E5100A-29B

Agilent E5100A/B Network Analyzer

Replacement of Floppy Disk Drive

Figure 1

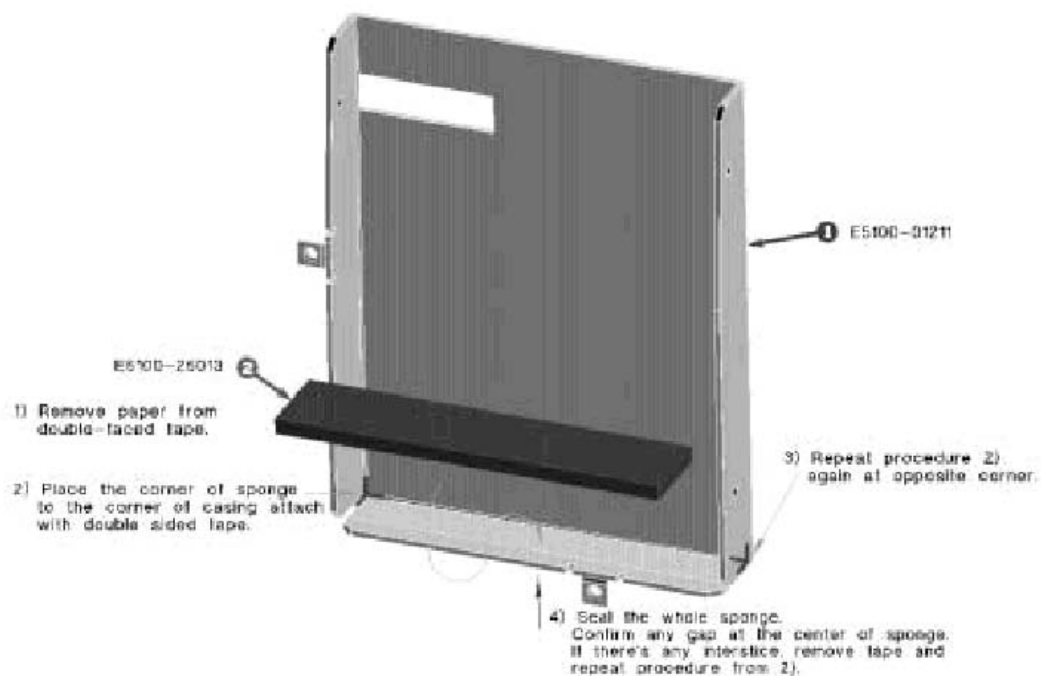
To assemble the FDD cover with sponges, see attached figures.
